Re: State Center Fire Department
Renovation & Addition – Redesign
109 E Main Street
State Center, Iowa 50247

ADDENDUM #01

January 06, 2026

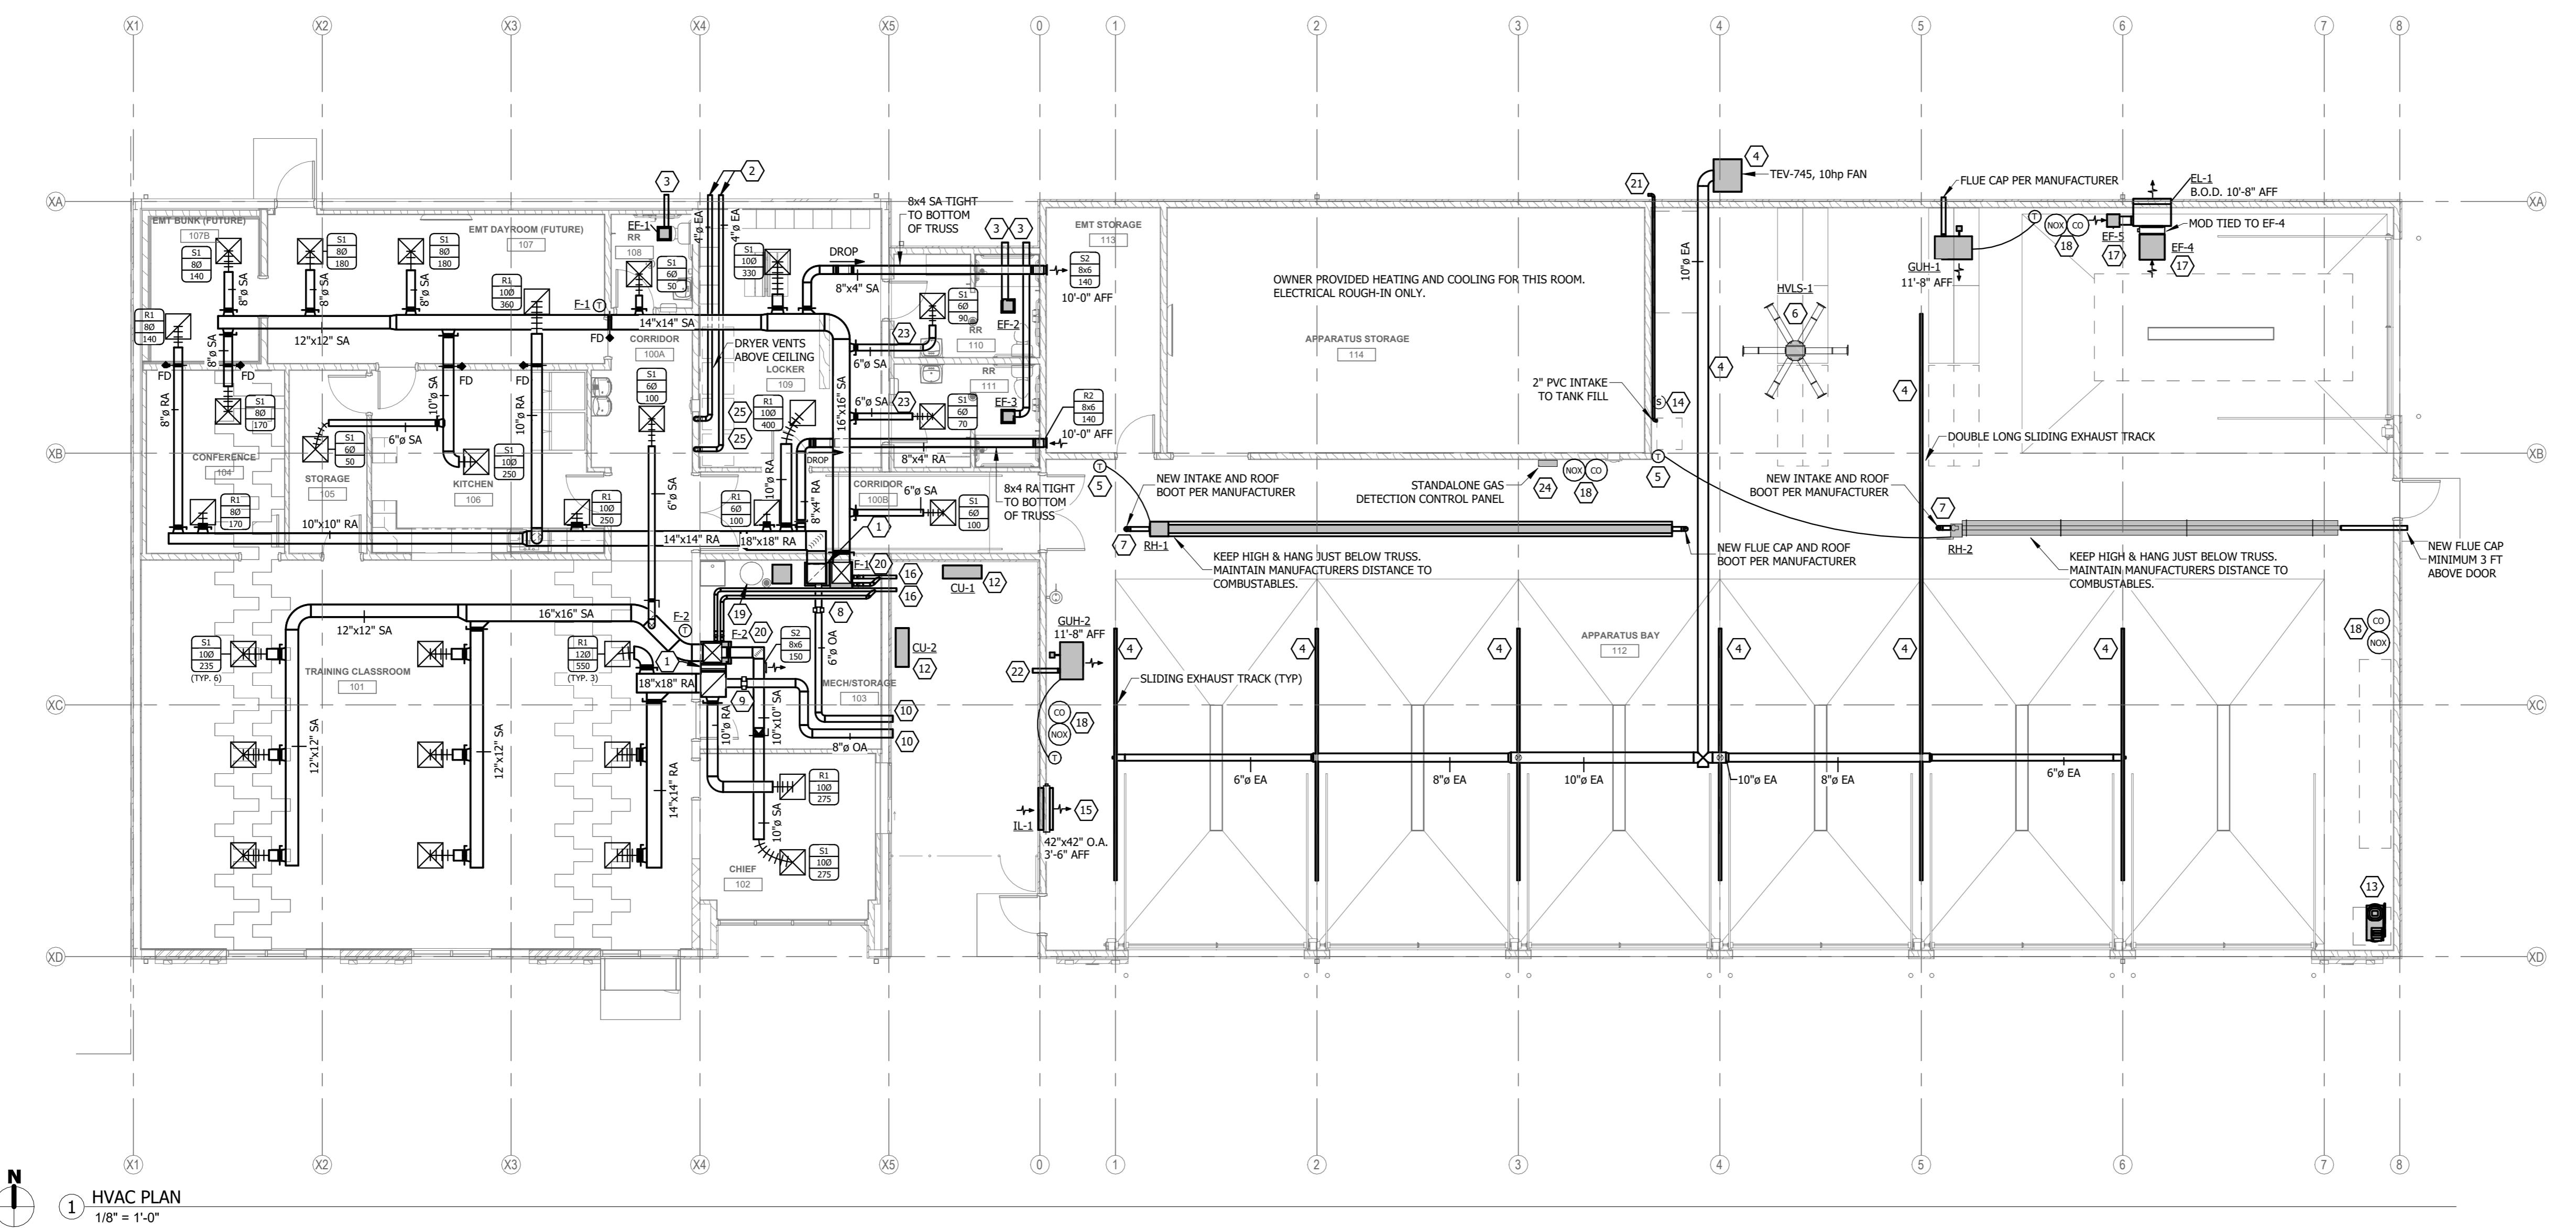
Sheet P1.1 – Piping Plan

1. Apparatus Bay 112
 - A. **ADD** Referenced Note 2 at GUH-2.
 - B. **REVISE** 2" and 4" vents from Sand Oil Interceptor to route up in south wall. Combine as 4" routed up in attic space to north peak in line with other roof penetrations. Maintain 10 ft from combustion air.
